SUBJECT: **Amendment to Fort St. Vrain NPDES Permit**

## **AMENDMENT NO. 5 - RATIONALE**

### **PUBLIC SERVICE COMPANY OF COLORADO FORT ST. VRAIN STATION**

**PERMIT NO. CO-0001121, WELD COUNTY**

Figure 8

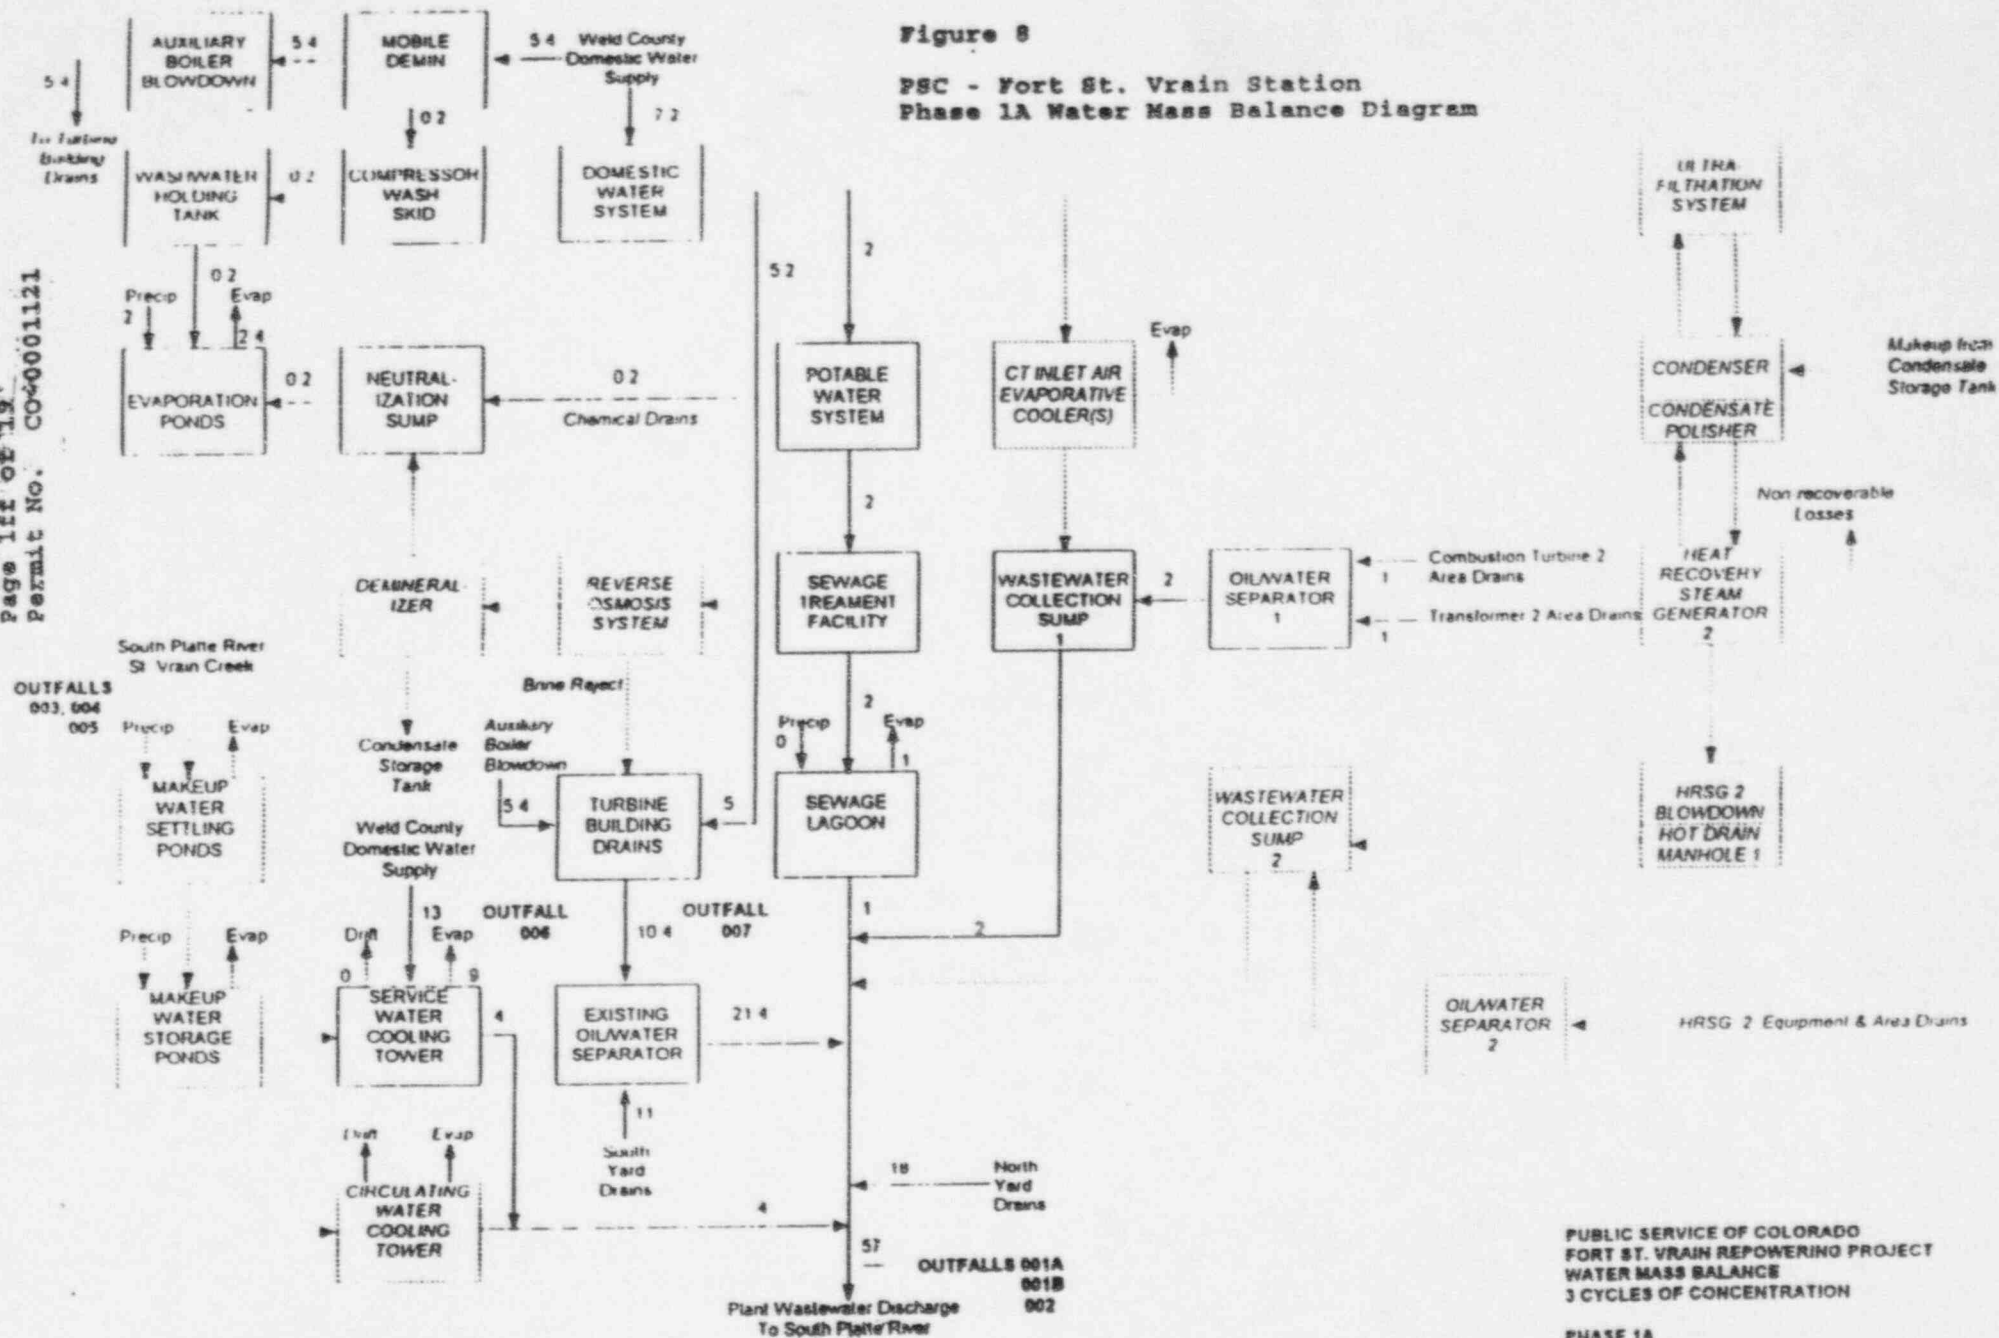
The only change that has been made in the permit for this amendment is the addition of figure 8 on page 1ff of 19. Figure 8 shows the Water Mass Balance Diagram which was submitted as part of this permit amendment.
